**HOUSTON-GALVESTON AREA COUNCIL**

July 20, 2010

## MEMORANDUM

**SUBJECT:** South Kirkwood Traffic Operations Assessment

Figure 2. Cross Section of Existing Conditions

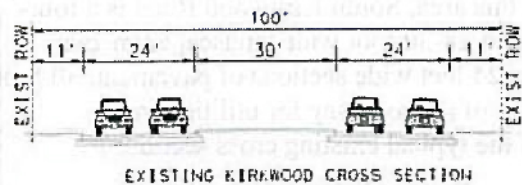
The section of study was on South Kirkwood Road between West Airport Boulevard and West Bellfort Street, just north of US 59 (see Figure 1). In this area, South Kirkwood Road is a four-lane boulevard section with curb and gutter drainage and 28-30 foot wide landscaped median with 100 foot wide right-of-way. This consists of two-24 foot wide sections of pavement, 30 foot landscaped median, and 11 feet wide area on both sides of the roadway for utilities and sidewalks (see Figure 2). Figure 3 shows a picture of the typical existing cross section.
